ADDENDUM NO. 1 – March 27, 2025

**Lathrop Animal Center – Stanford Crossing Extension
CIP GG 23-11**

This addendum amends the Contract Drawings and Specifications for this project as follows:

**STANFORD CROSSING EXTENSION**  
**PLAN AND PROFILE STA. 6+00.00 TO STA. 10+54.82**  
**DOS REIS ROAD WIDENING**  
 DEPARTMENT OF PUBLIC WORKS  
 CITY OF LATHROP, CALIFORNIA

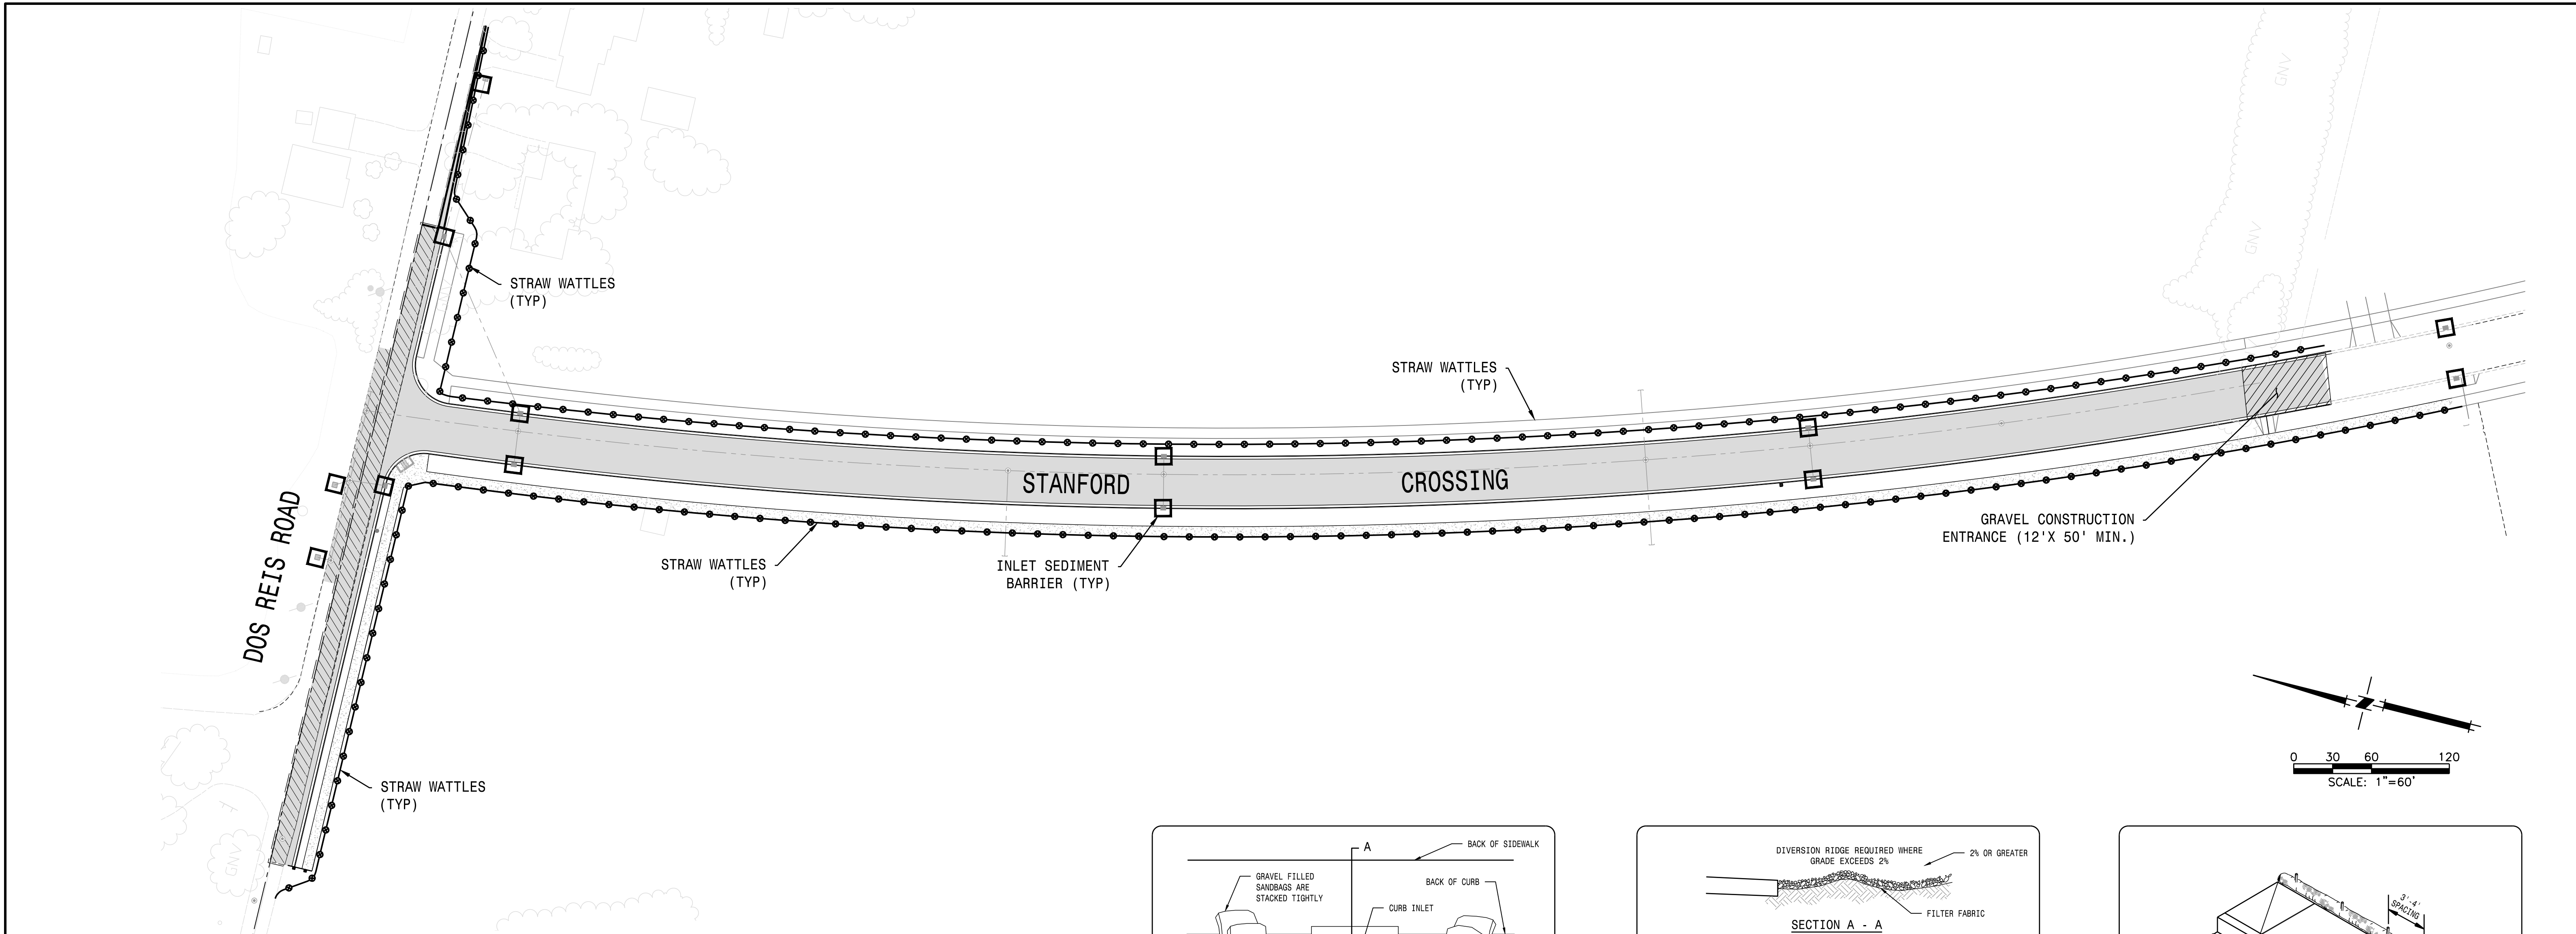
1. Revised the scope of work from 100 to 650 linear feet of road widening on Dos Reis Road.
2. Revised Bid Schedule Items:
 - a. #4 Rough Grading from 3,842 to 3,700 CY
 - b. #6 Construct Street Structural Section (3.5" AC, 4" AB, 10" LTB) from 63,164 to 65,146 SF
3. Revised Improvement Plans – see Attachment A of this Addendum.
